# Modification Notice - Regulation 22

Interest Holder	Central Petroleum	EMP Title	Mereenie Development Wells WM29 / WM30	Unique EMP ID No.	CTP7-5	Mod No.	2	Date	9 July 2024
Brief Description	<p>This Regulation 22 modification is seeking to amend the EMP to:</p> <ul style="list-style-type: none"> <li>Update Tables 2 and 7, as through the development of this modification, it has been noted that the clearing footprint stipulated for the flowlines for each new well are contrariwise. The original clearing area for WM29 flowlines should be 1.1ha and 0.45ha for WM30.</li> <li>Relocate the proposed flowline connection from the West Mereenie 29 Well to the West Mereenie 300 (WM300) line which connects to the Central Treatment Plant (CTP).</li> </ul> <p>The <u>existing</u> flowline alignment detailed in the approved EMP (CTP7-5) indicates the flowline from WM29 will run along southern side of the main access road and tie into the WM300 spin line (EMP figure 3). This approach requires approximately 700m of clearing of approximately 25m in width for fire management and ongoing maintenance of the new flow line resulting in approximately 1.1ha of ground disturbance.</p> <p>The <u>proposed</u> m

Attachment 2: Revised Figure 3

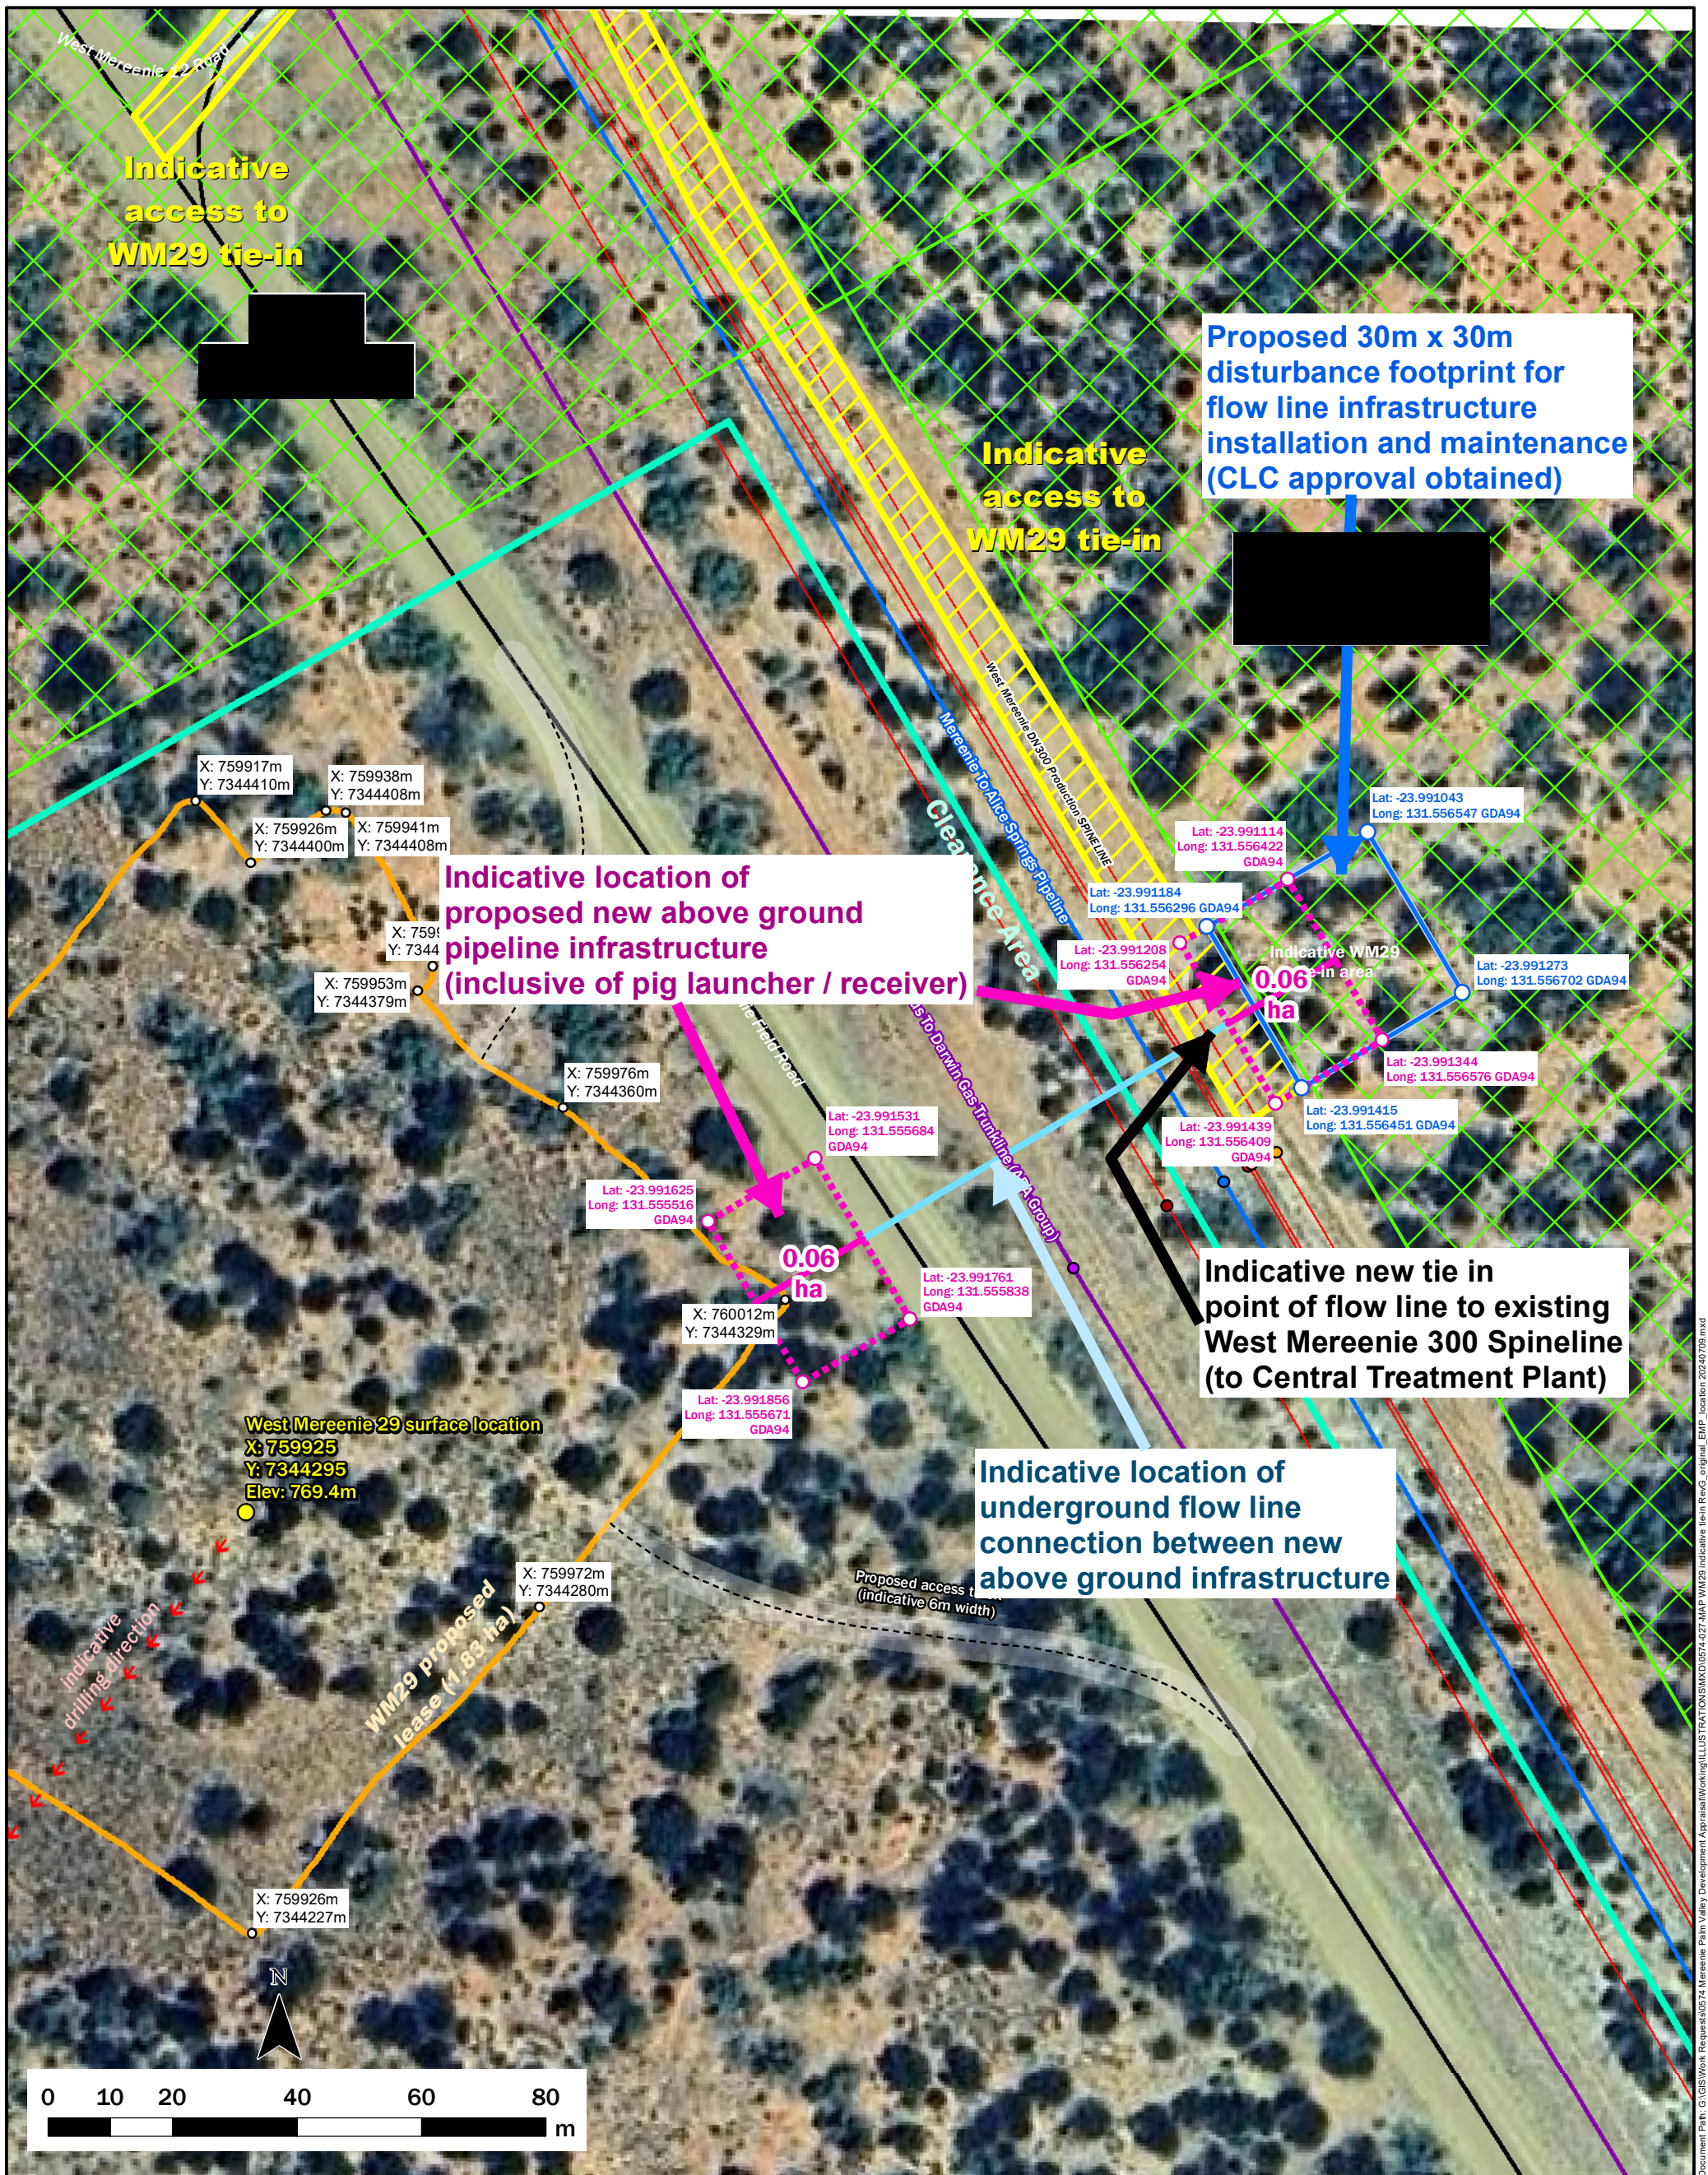
Revised Figure 3 - Refer to Attachment 2

Flow line tie in modification – Risk Assessment			
Category	Currently approved option	Proposed option	Differences / Comments
<b>Required ground disturbance</b>	The current proposed ground disturbance footprint for the WM29 flowline = <u>1.11ha</u>	The new proposed ground disturbance footprint for the WM29 flowline = <u>0.17ha</u>	The proposed update to the flow line alignment will result in a 0.94ha reduction in ground disturbance and vegetation impacts. There is a clear environmental benefit to be gained by implementing the flow line realignment.
<b>Flora and fauna impacts</b>	The ecological assessment undertaken for WM29 did not identify any threatened flora or fauna within the clearing footprint however, incidental flora impacts were associated with the proposed alignment and resulted in approximately 0.45ha of clearing.	The ecological assessment undertaken for WM29 included the area proposed to be disturbed by the flowline realignment. These were no instances of threatened fauna of flora noted in this location either however, clearing of vegetation is significantly reduced through implementation of the new alignment.	As above, the updated flow line alignment results in approximately 0.94ha less clearing of vegetation and potential fauna habitat.
